Approval of a Certificate of Appropriateness – 1111 W. Turner Street

Historical Architectural Review Board FINAL Review Sheet

HDC-2024-00019

Address: 1111 W Turner Street

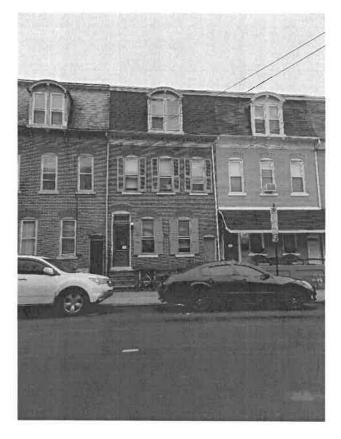
<u>Observations & Comments:</u> The roof replacement is not an in-kind replacement. From reviewing Google Street View images prior to the replacement, the original roofing was a 3-tab shingle; yet the replacement material is an architectural shingle with an exaggerated taper and overlap, which is not a suitable alternate for historic slate roofing. It does appear that an adjacent house has a similar architectural shingle, while the neighboring house in the other direction has slate roofing.

Staff Recommendation: It is recommended to deny.
